Subject: Minutes for 51st Protection Sub-Committee Meeting.

51st Protection Sub-Committee Meeting (23rd July, 2024)-MoM

**Minutes of
51st Meeting of Protection Sub-Committee (PSC) of
Northern Regional Power Committee**

DR of 220 kV Sarna(PS) (end)-Dasuya(PS) (PG) Ckt-1

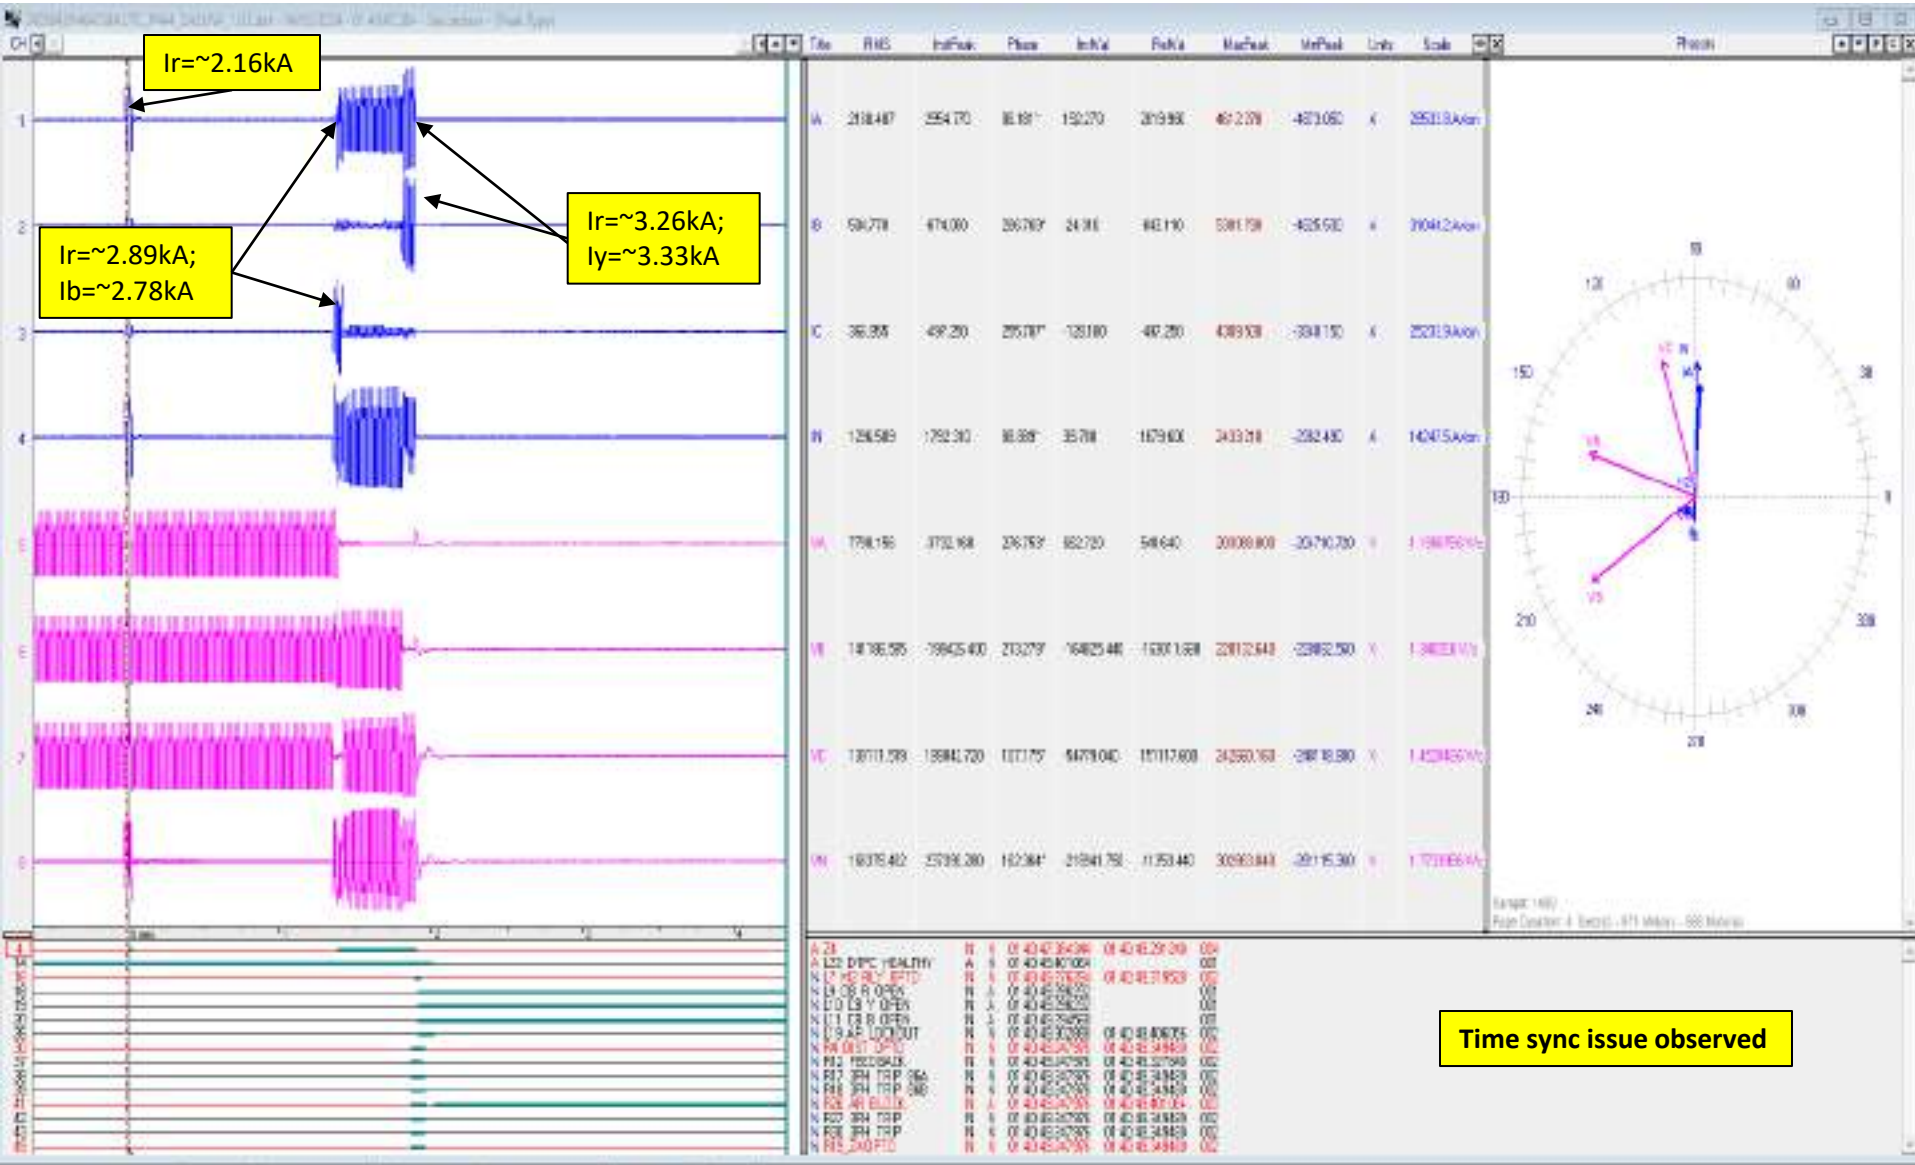
- ✓ R-N phase to earth fault followed by R-B-N double phase to earth fault converted to R-Y-N double phase to earth fault
- ✓ Zone-4 operated after a delay of ~528 ms at Sarna(PS) end

DR of 220 kV Sarna(PS) -Dasuya(PS) (end) (PG) Ckt-1

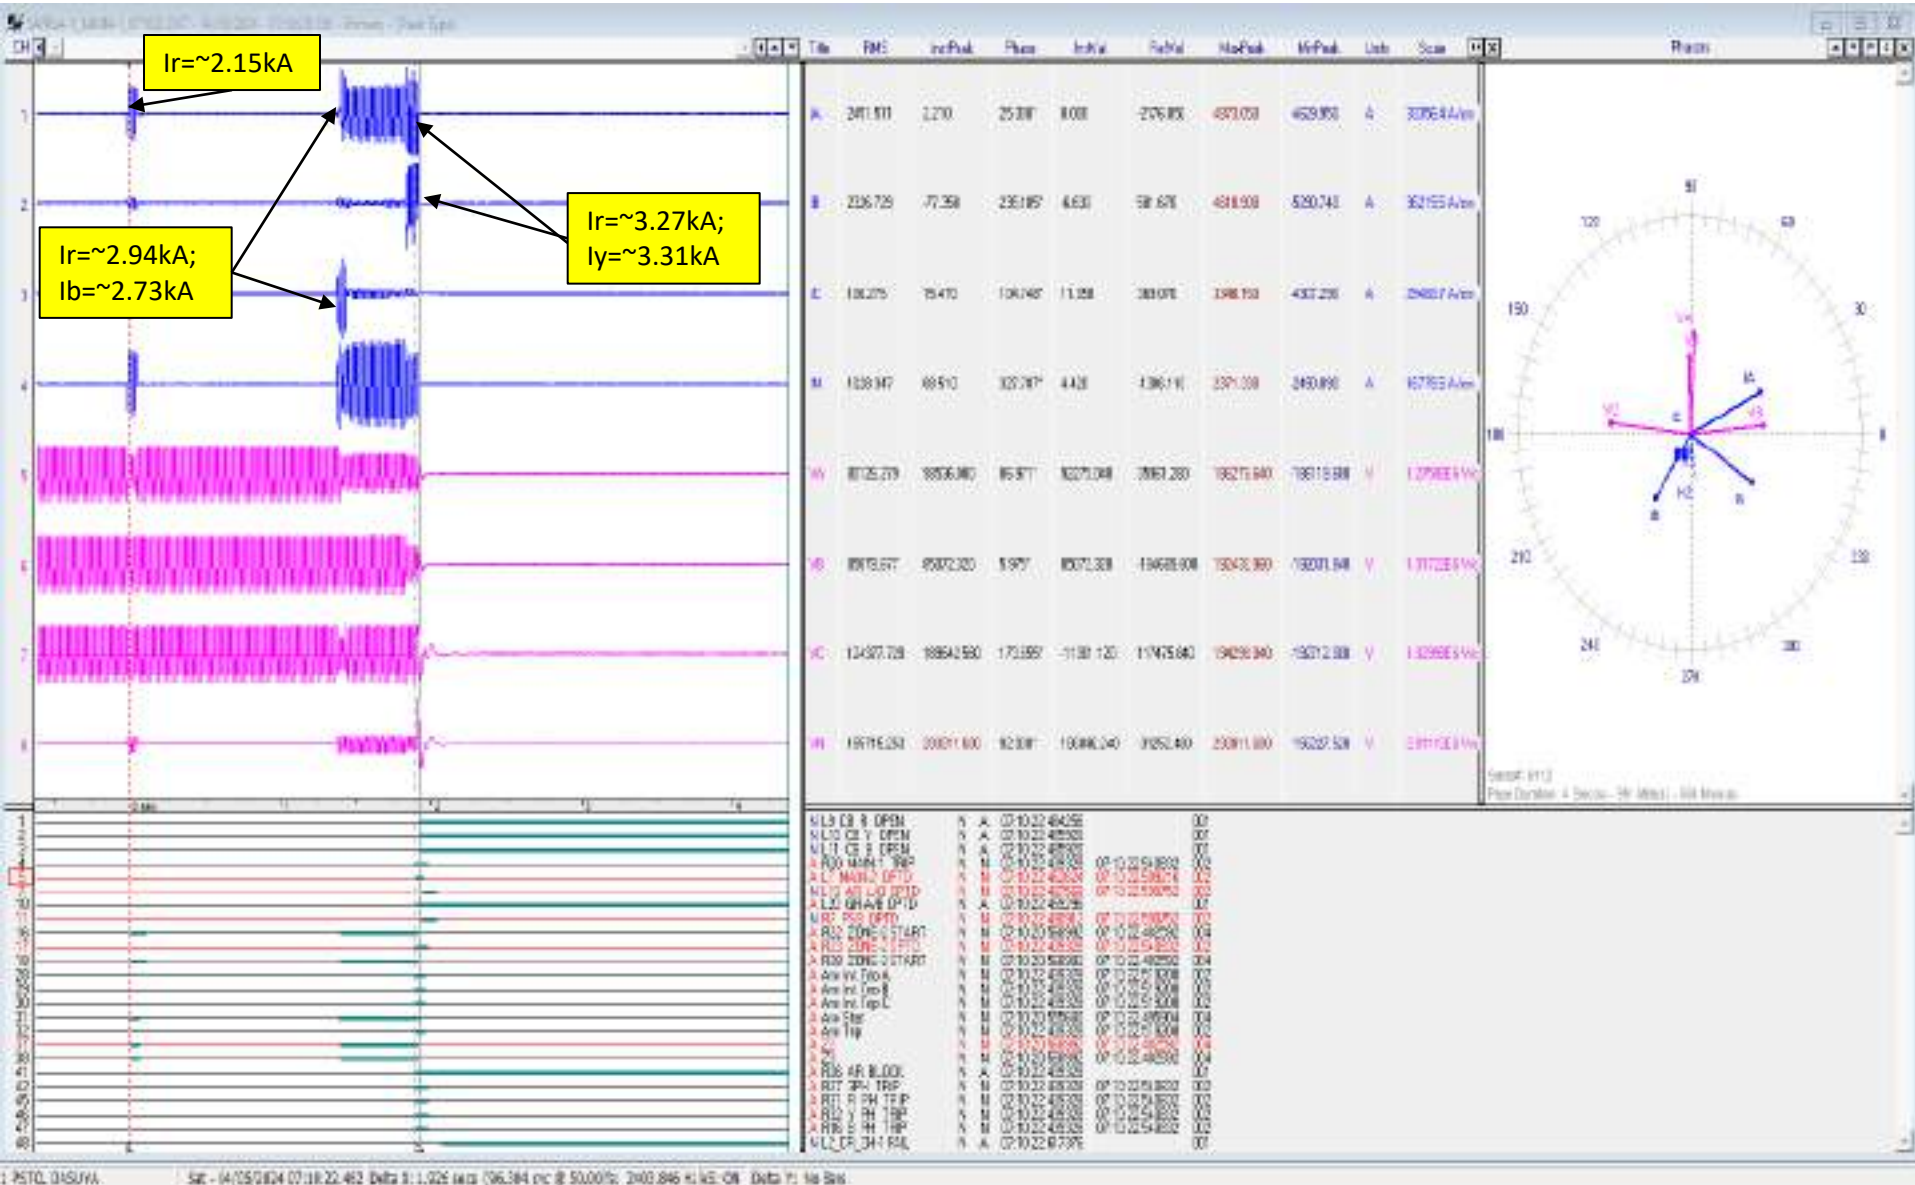
- ✓ R-N phase to earth fault followed by R-B-N double phase to earth fault converted to R-Y-N double phase to earth fault
- ✓ Zone-2 operated after a delay of ~532 ms at Dasuya(PS) end

DR of 220 kV Sarna(PS) (end)-Dasuya(PS) (PG) Ckt-2

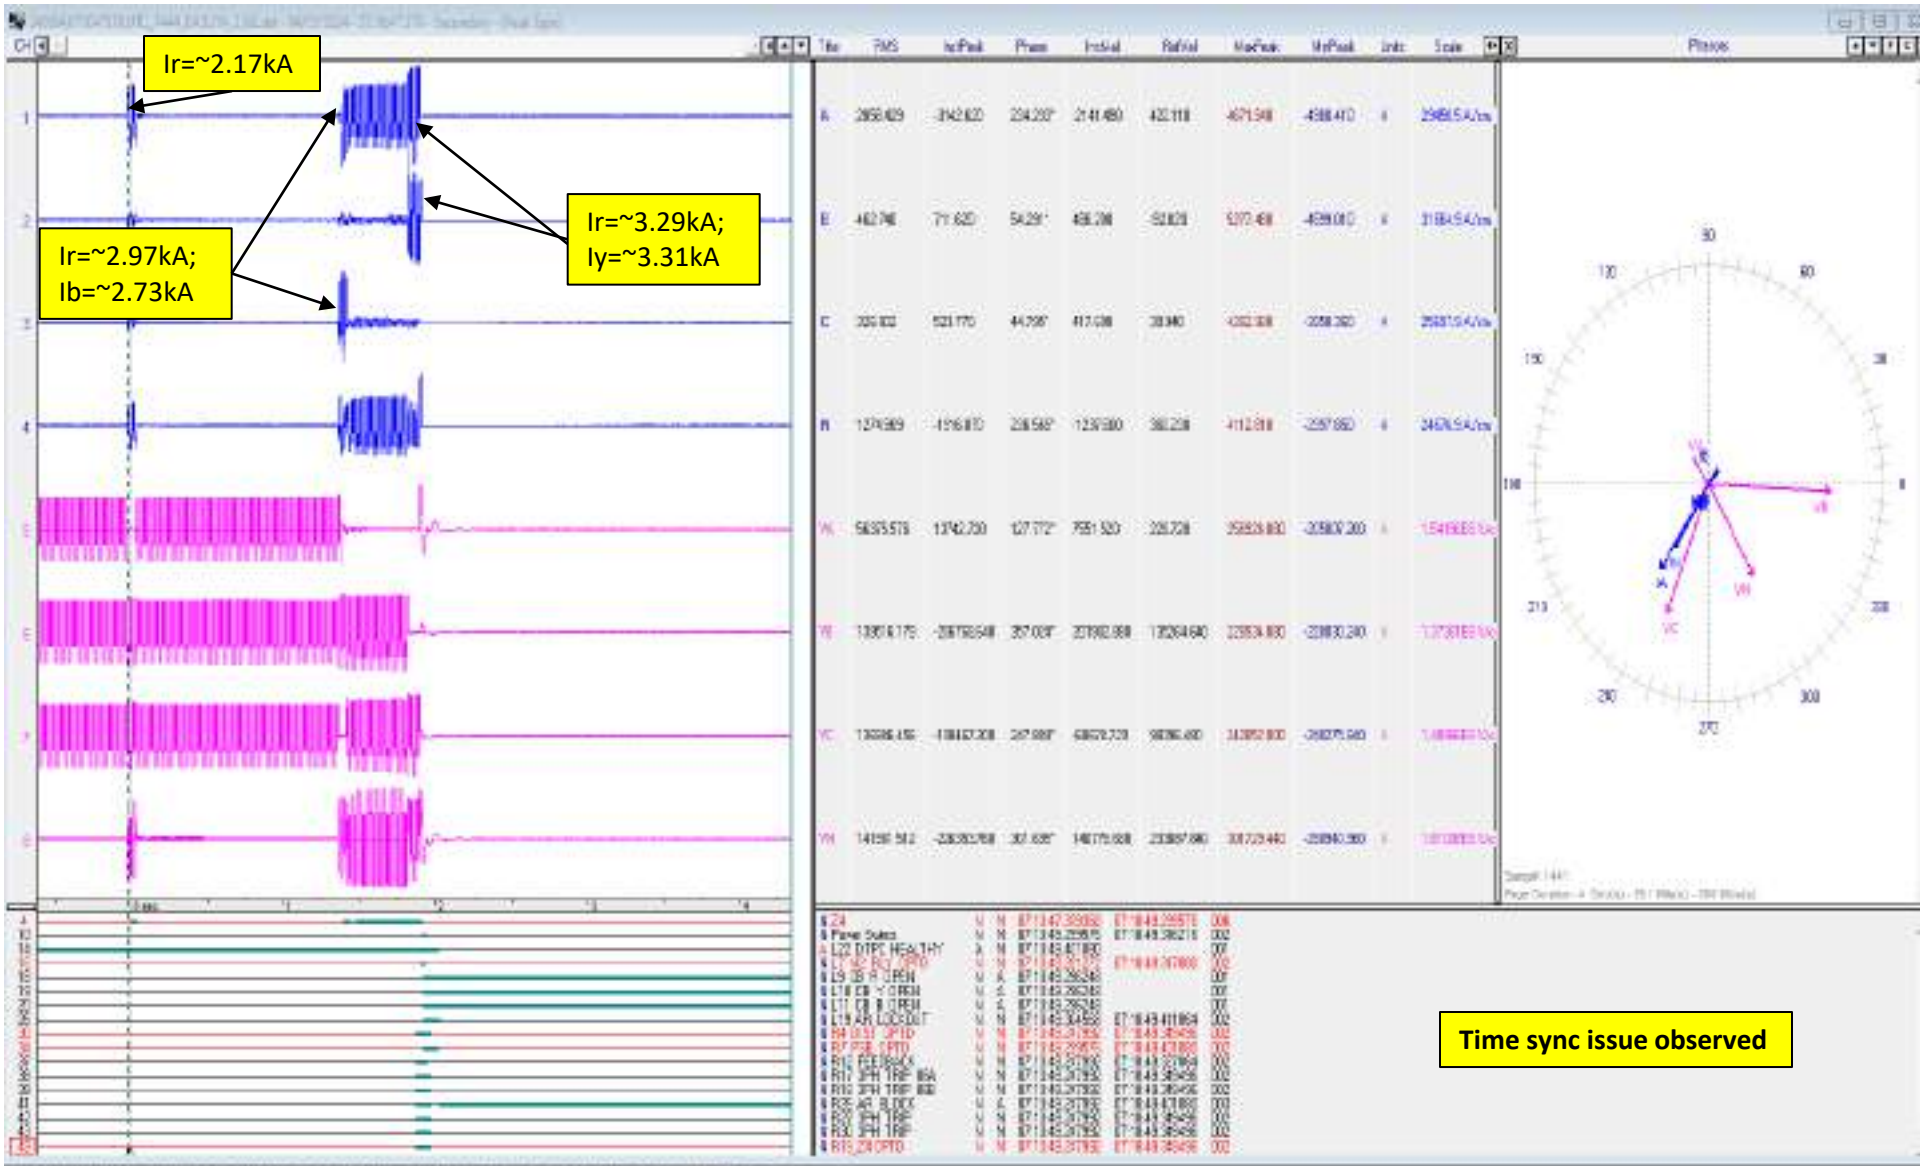
- ✓ R-N phase to earth fault followed by R-B-N double phase to earth fault converted to R-Y-N double phase to earth fault
- ✓ Zone-4 operated after a delay of $\sim 526 \text{ ms}$ at Sarna(PS) end

DR of 220 kV Sarna(PS) -Dasuya(PS) (end) (PG) Ckt-2

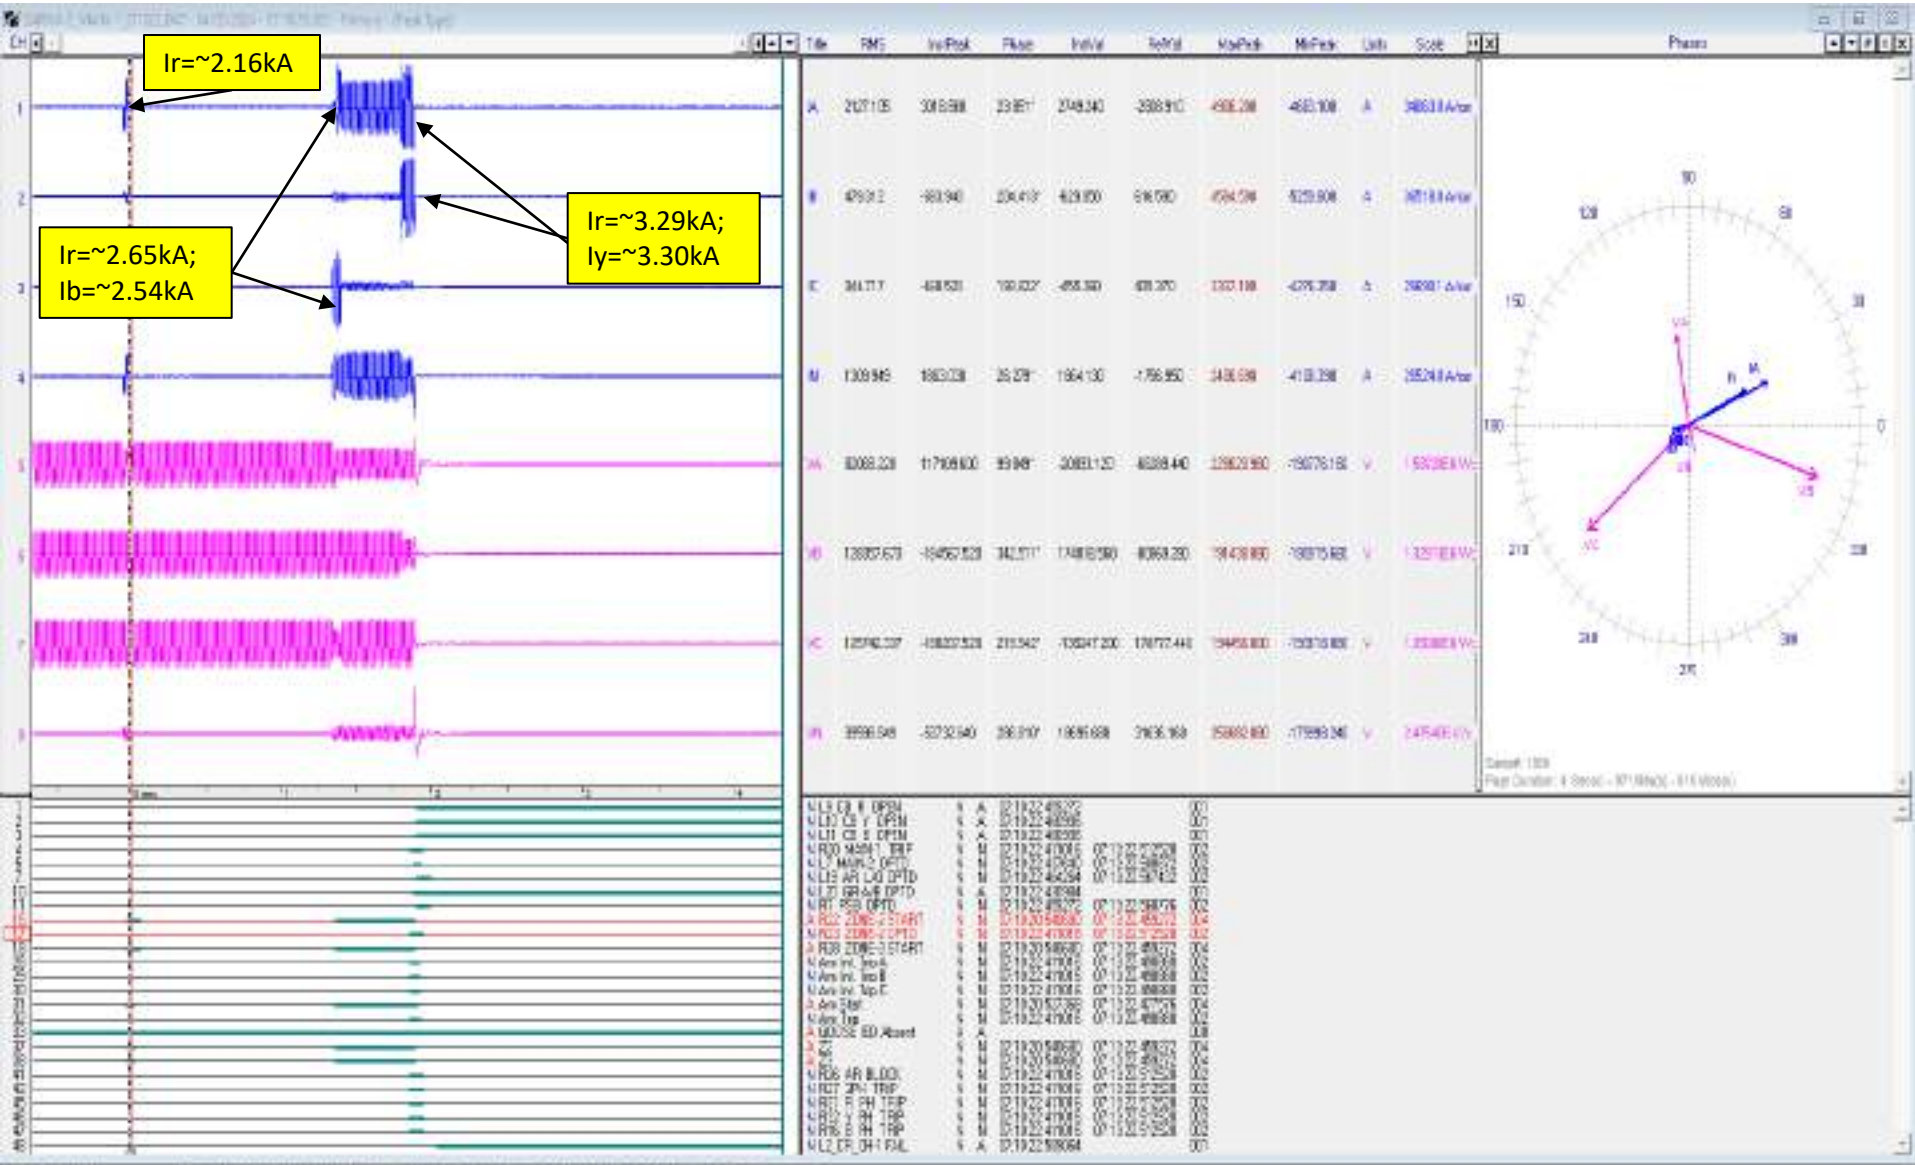
- ✓ R-N phase to earth fault followed by R-B-N double phase to earth fault converted to R-Y-N double phase to earth fault
- ✓ Zone-2 operated after a delay of ~538 ms at Dasuya(PS) end

DR of 220 kV Kishenpur(PG) (end)-Sarna(PS) (PG) Ckt-2

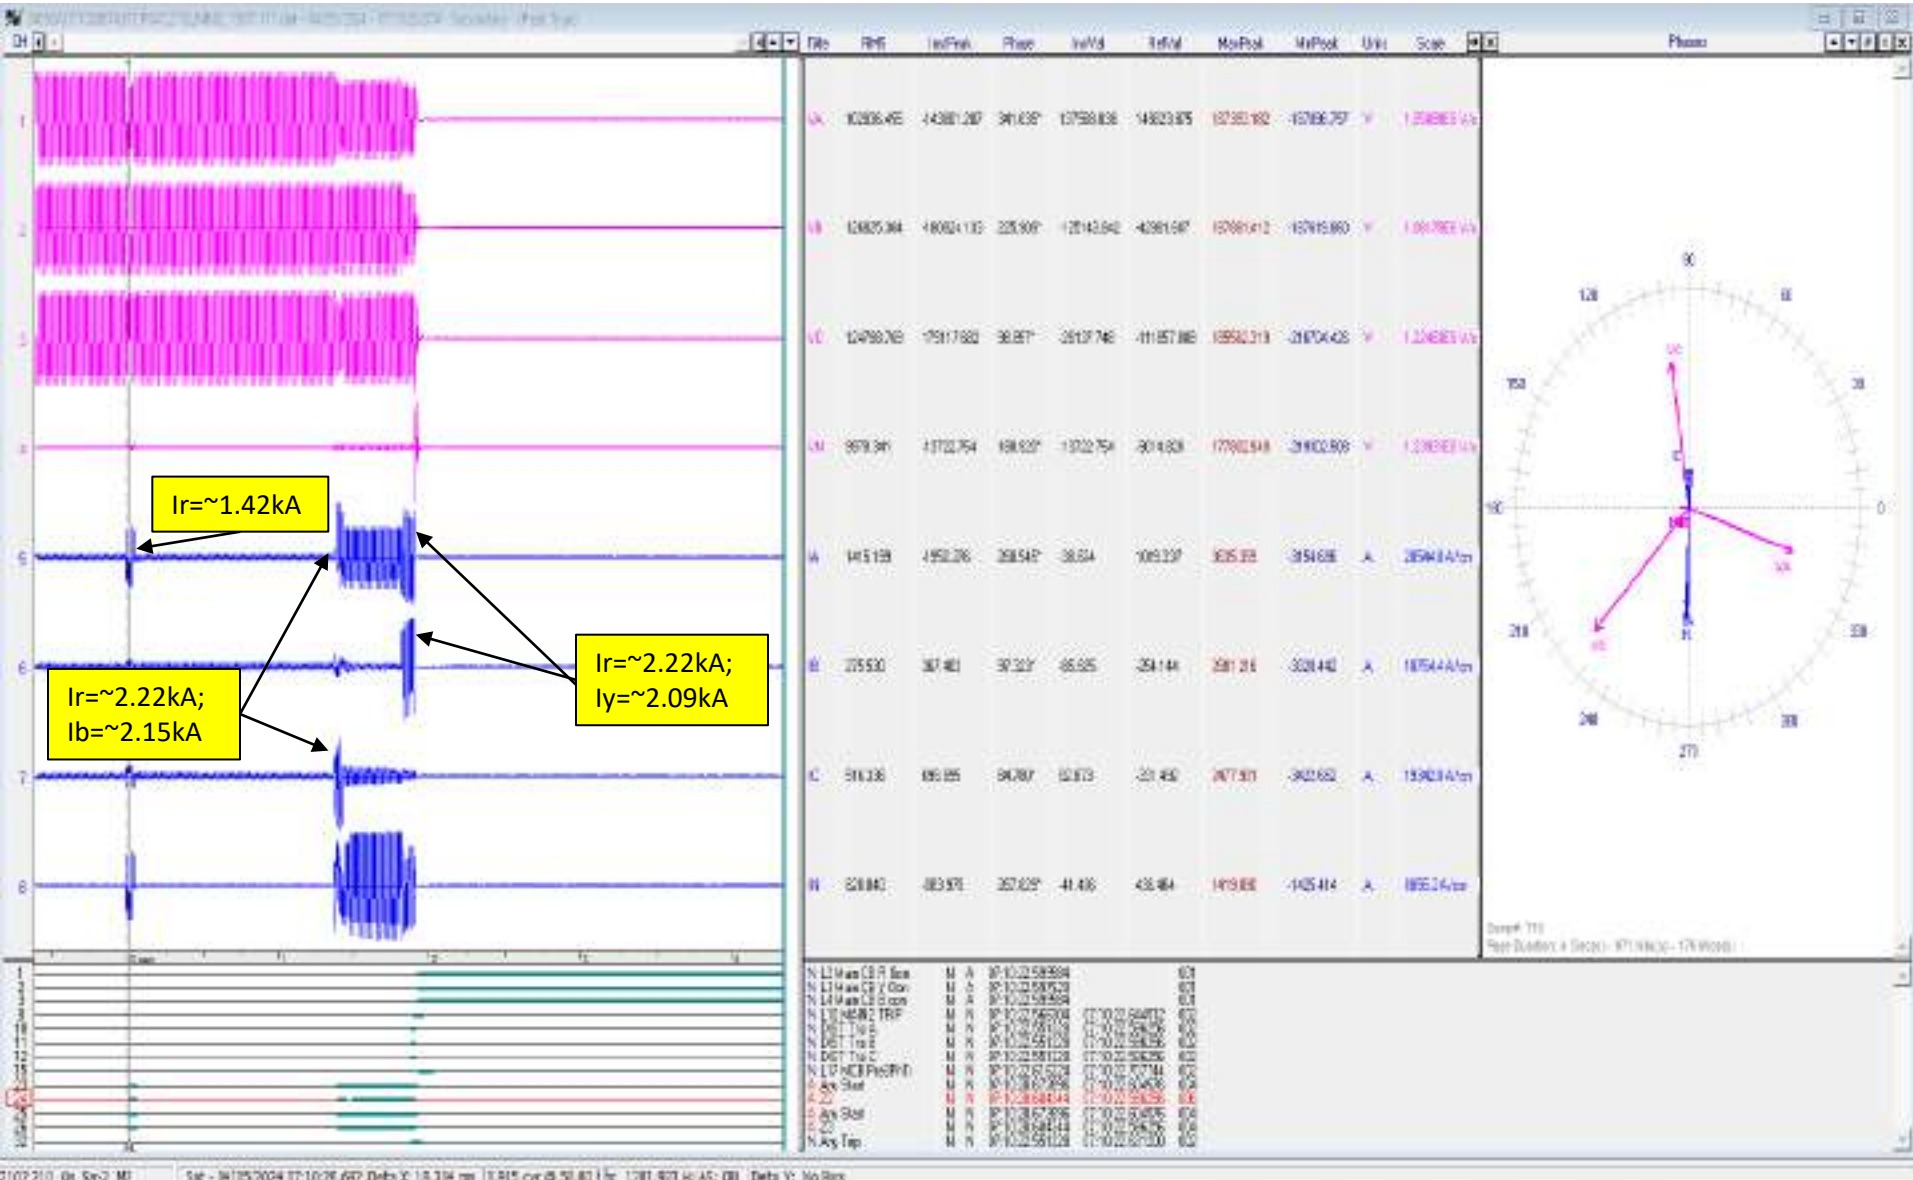
- ✓ R-N phase to earth fault followed by R-B-N double phase to earth fault converted to R-Y-N double phase to earth fault
- ✓ Zone-2 operated after a delay of ~ 538 ms at Kishenpur(PG) end
